REFERENCE:	Nova Bus Manuals
SECTION:	16: 24-Volt Electrical System
RS N°:	N/A
EFFECTIVE IN PROD.:	L621 (2011AL)

APPLICATION DEADLINE: 2015AL17
CLAIM REFERENCE NUMBER: WB-3080

SUBJECT:	V-BEA module
JUSTIFICATION:	CECM could be replace with a MCM module to reduce download time

Figure 2 - Connection of Cable N64010 and N64011 to MCM Module

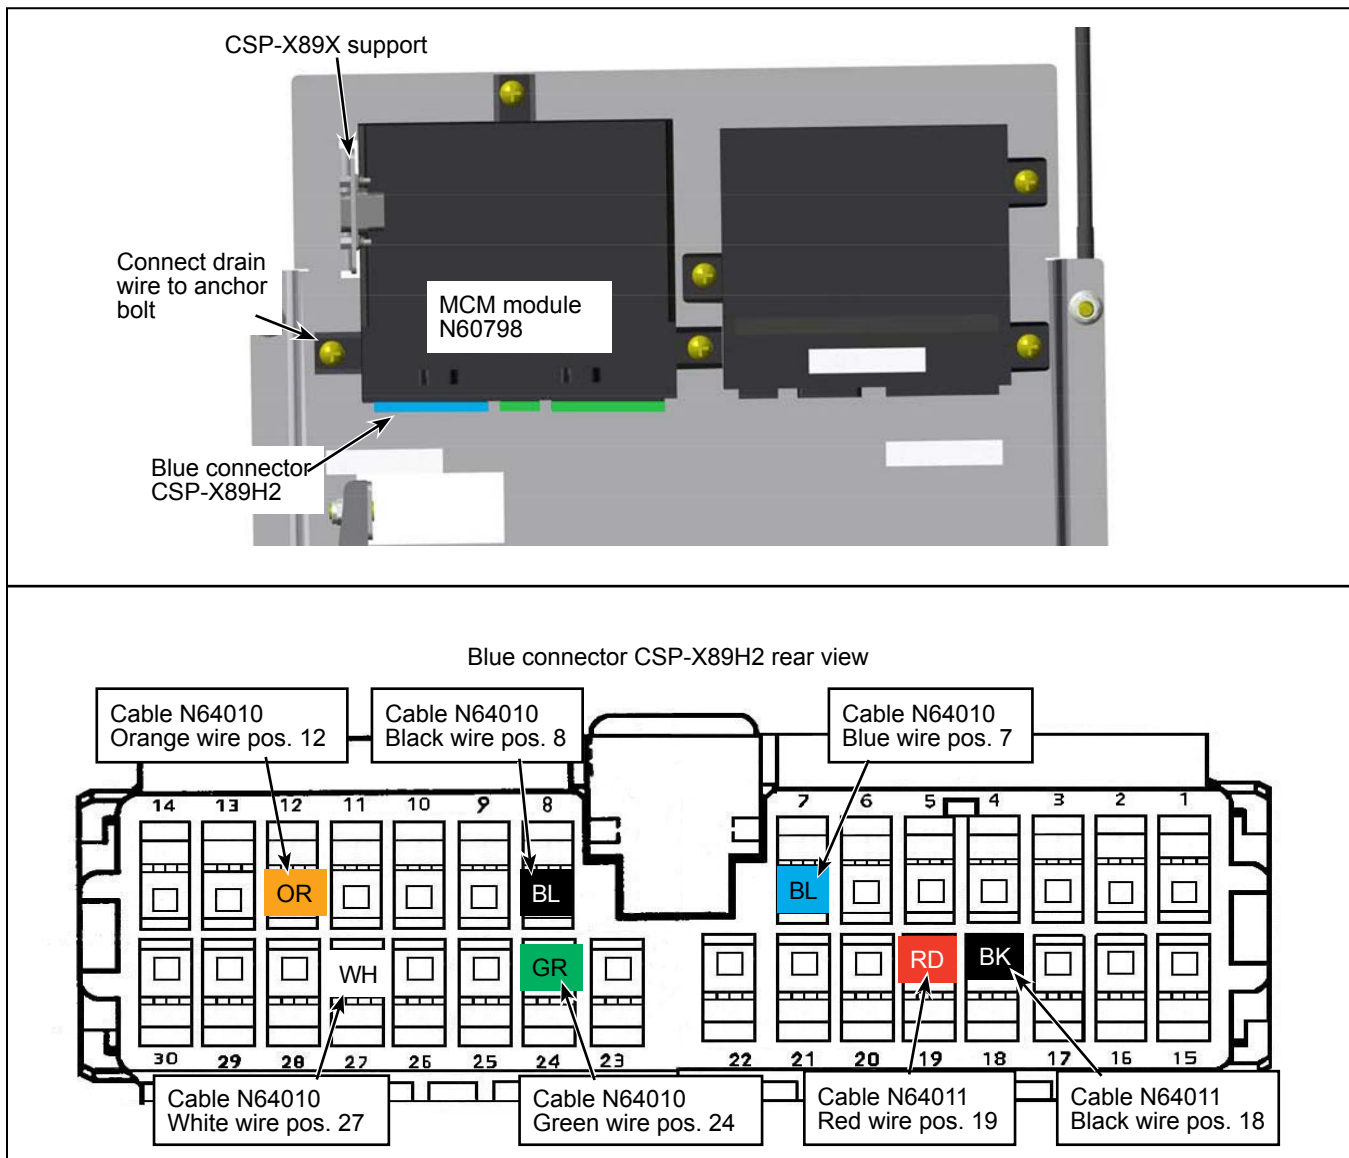
- 1.11. Connect cable N64010 to cable N60809 on **CSP-X89X** connector support in the operator's control panel. See Figure 2.
- 1.12. Disconnect the blue connector **CSP-X89H2** from the CECM module. See Figure 2.

- 1.13. Connect all colored wires (green, white, orange, blue and black) of cable N64010 in the connector **CSP-X89H2**. See Figure 2 for pin position.

- 1.14. Replace module CECM with new module MCM N60798, using the same hardware. See Figure 2.
- 1.15. Connect drain wire of cable N64010 to one of the anchor bolts on module MCM (N60798). See Figure 2.

- 1.16. Connect the black and red wires of cable N64011 in the blue connector **CSP-X89H2**. See Figure 2 for pin position.

Figure 3 - Cable N64011 and N64009 Connection in Main Panel

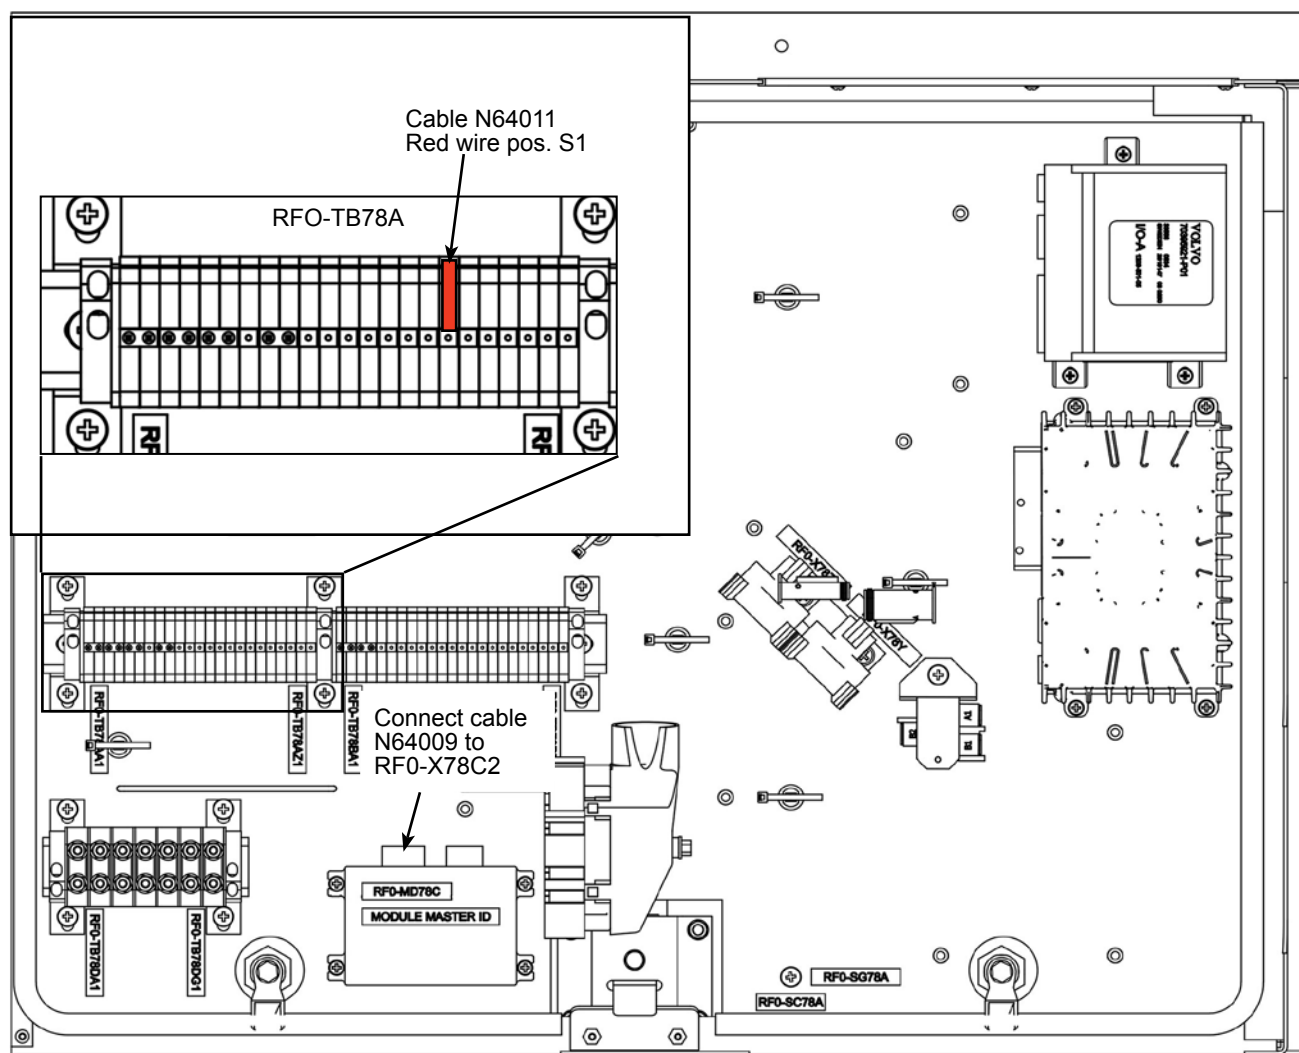
- 1.17. Close the overhead console door, located above the operator's window.
- 1.18. Open the left electrical Main Panel door.
- 1.19. Route cable N64011 inside the left portion of the Main Panel. Secure the cable using tie wrap.
- 1.20. Connect the red wire of cable N64011 to the Main Panel terminal block RF0-TB78A-S1. See Figure 3.
- 1.21. Connect black wire of cable N64011 to the Main Panel splice connector RF0-SC-78A, position H.
- 1.22. Disconnect cable **RF0-X78C2** from the Master ID module. See Figure 3.
- 1.23. Connect cable N64009 to connector **RF0-X78C2**. See Figure 3.

Figure 7 -

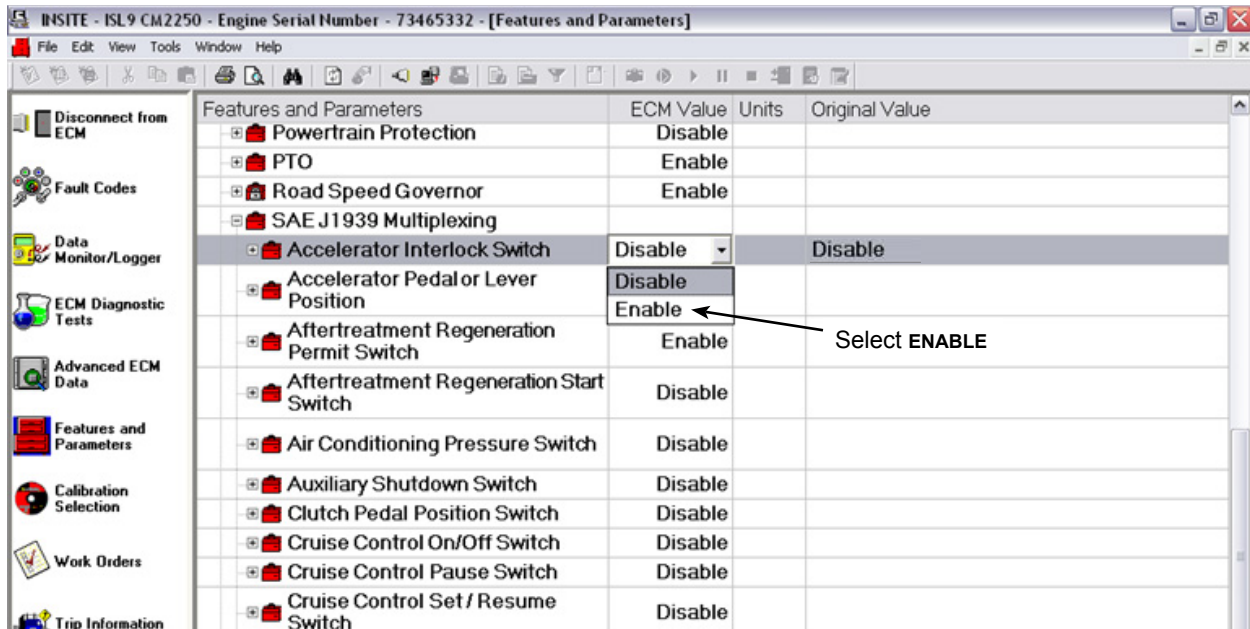
- 3.7. Change the **ACCELERATOR INTERLOCK SWITCH** parameter from **DISABLE** to **ENABLE**. See Figure 7.
